**Re: Multi-Family Residential at 15584 SW Old Scholls Ferry Road Beaverton, OR  
CWS file 20-000306 (Tax map 2S105BA Tax lot 00200)**

Clean Water Services has reviewed the Amended Service Provider Letter issued on April 22, 2022 for file 20-000306. Staff has evaluated the Service Provider Letter conditions and the currently proposed site plan addressing the City's Climate Friendly and Equitable Communities standards and found the revised site plan to be in compliance with Resolution and Order 19-5 (R&O 19-5), as amended by Resolution and Order 19-22 (R&O 19-22). This approval does not include any changes or modifications to the encroachment, enhancement, or mitigation of sensitive area or Vegetated Corridor as outlined in the Service Provider Letter.

# AMENDED Service Provider Letter

**SCHOLLS FERRY APARTMENTS CWS-SPL**

**BUFFER IMPACTS**

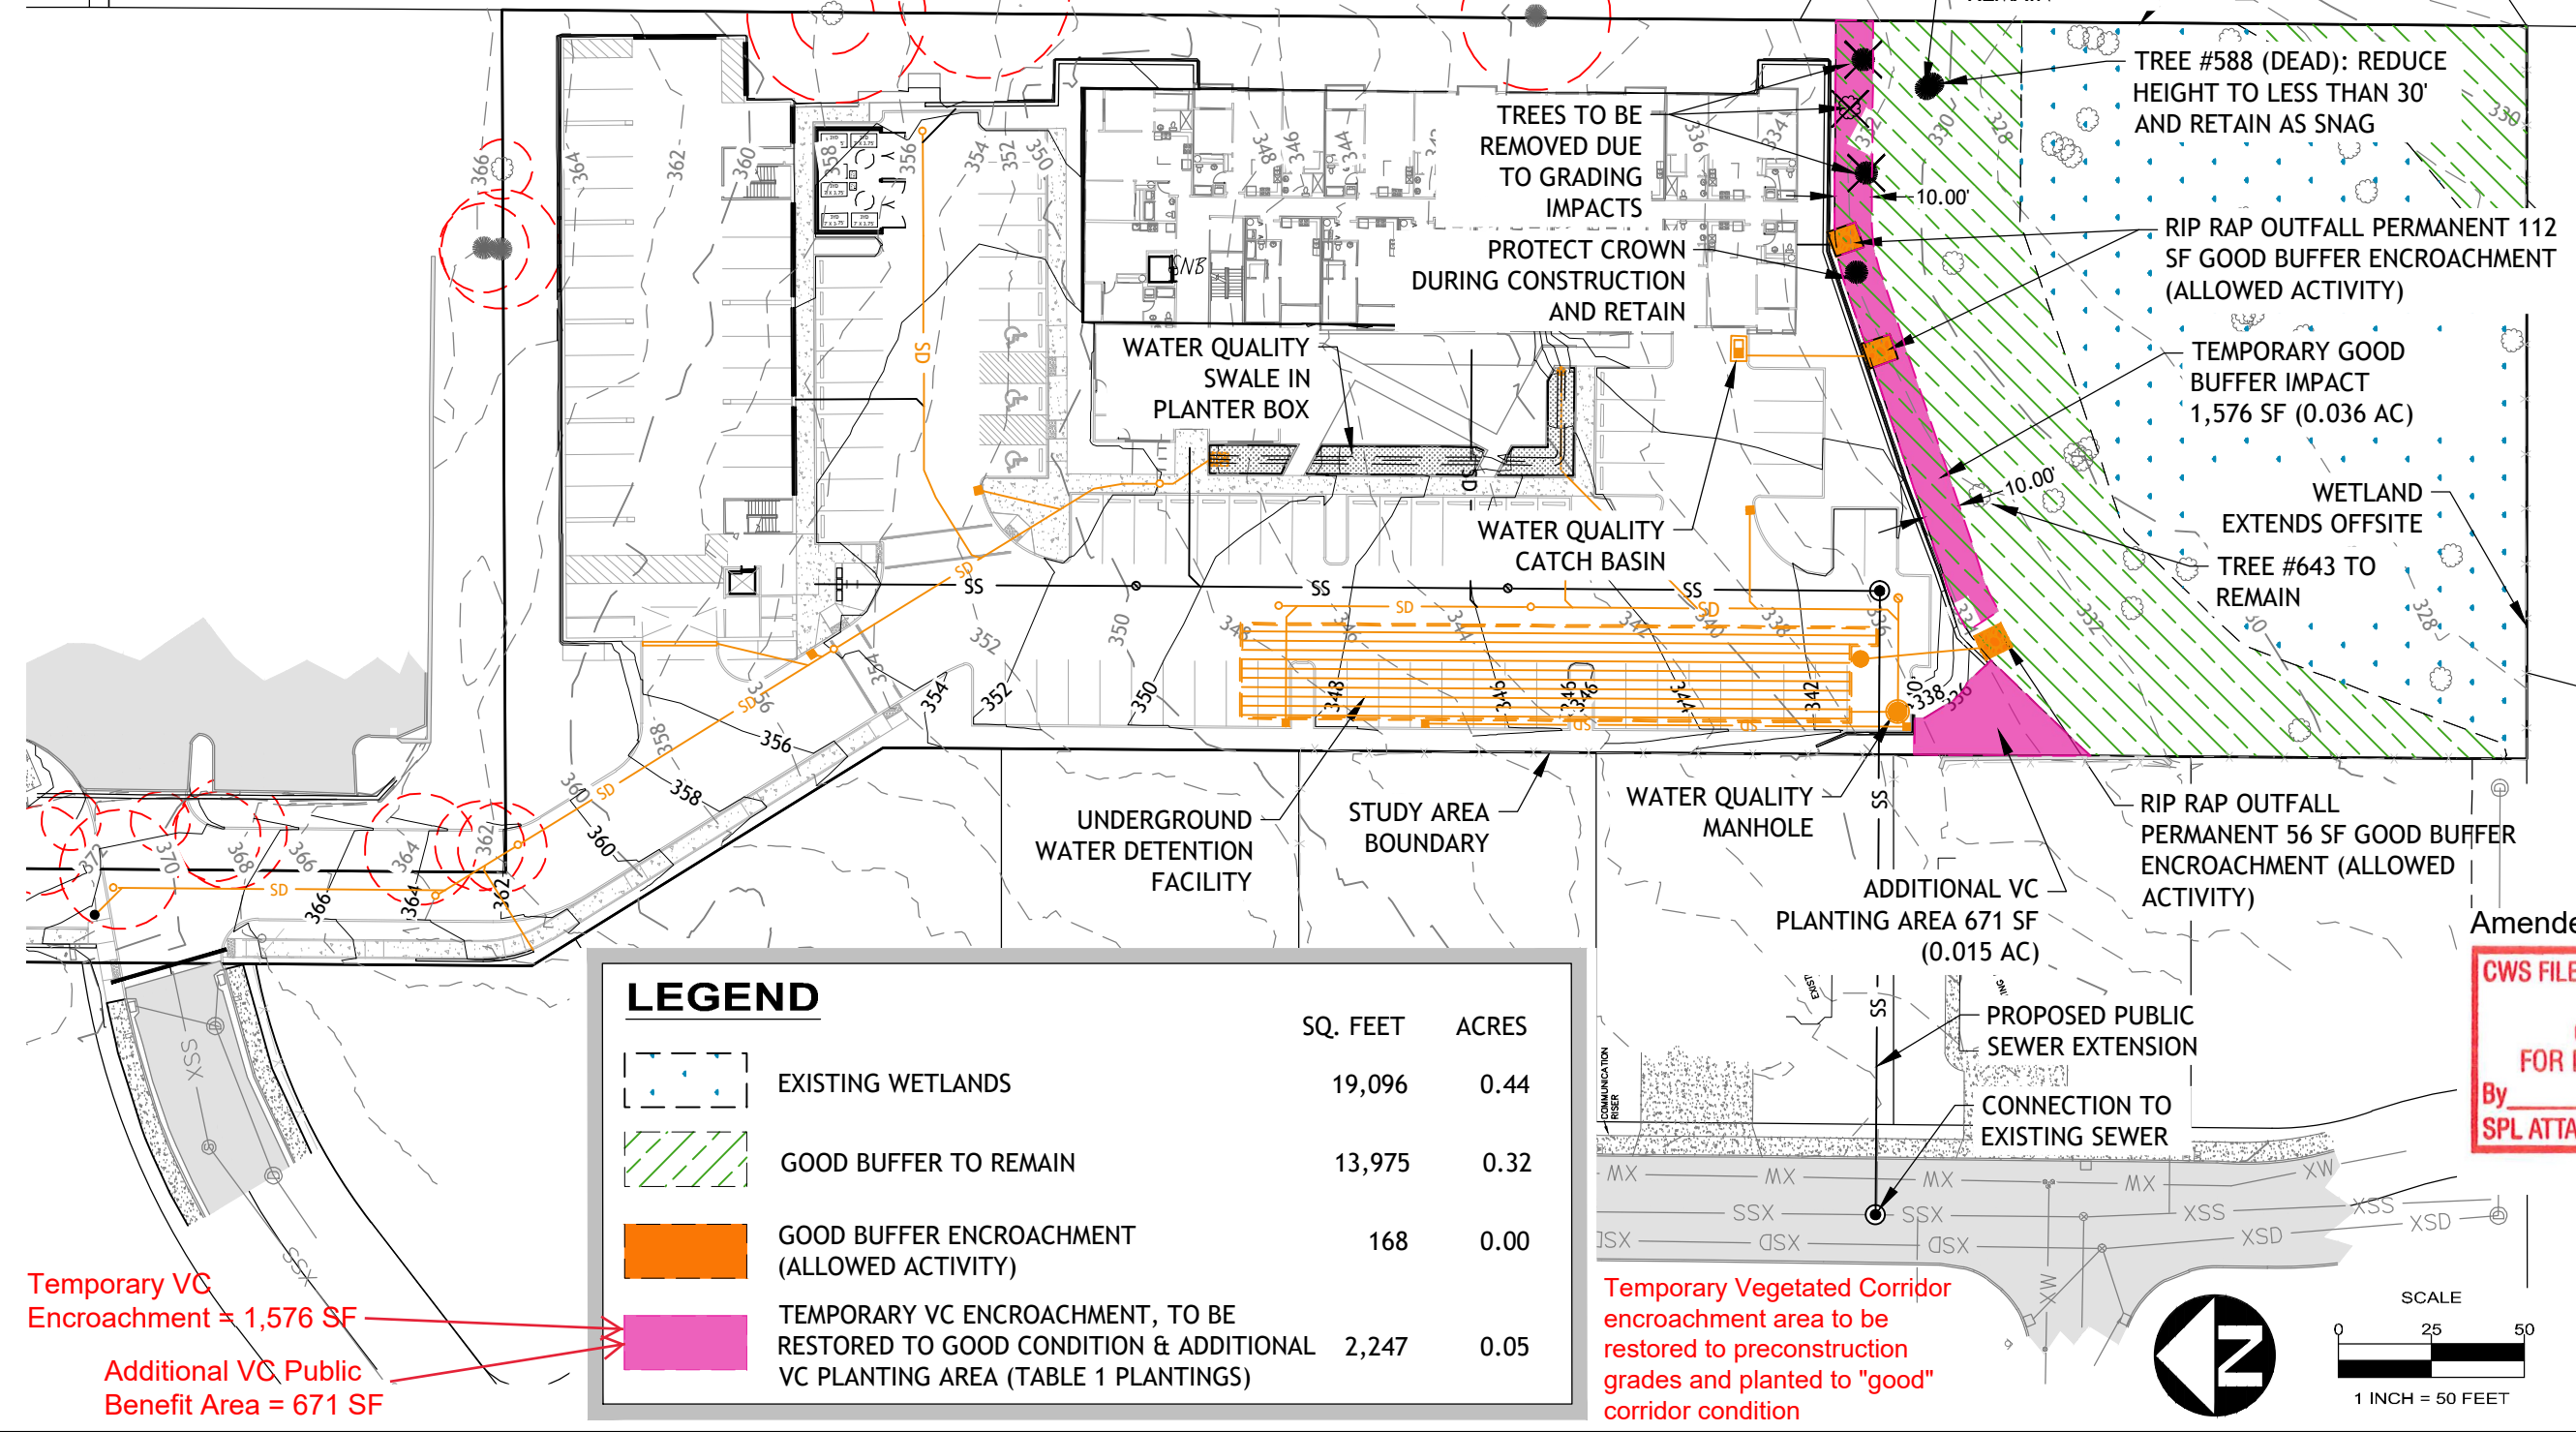
Type and location of Encroachment:	Square Footage:
<u>Temporary construction Access for retaining wall (Temporary encroachment; Restoration to preconstruction grade and planting to good condition inplace required)</u>	<u>1,576</u>
<u>Stormwater outfall (Permanent Encroachment; No mitigation required)</u>	<u>168</u>

Type/Location	Sq. Ft./Ratio/Cost
<u>On-site/Restoration of Temporary Encroachments and additional Public Benefit</u>	<u>2,247</u>
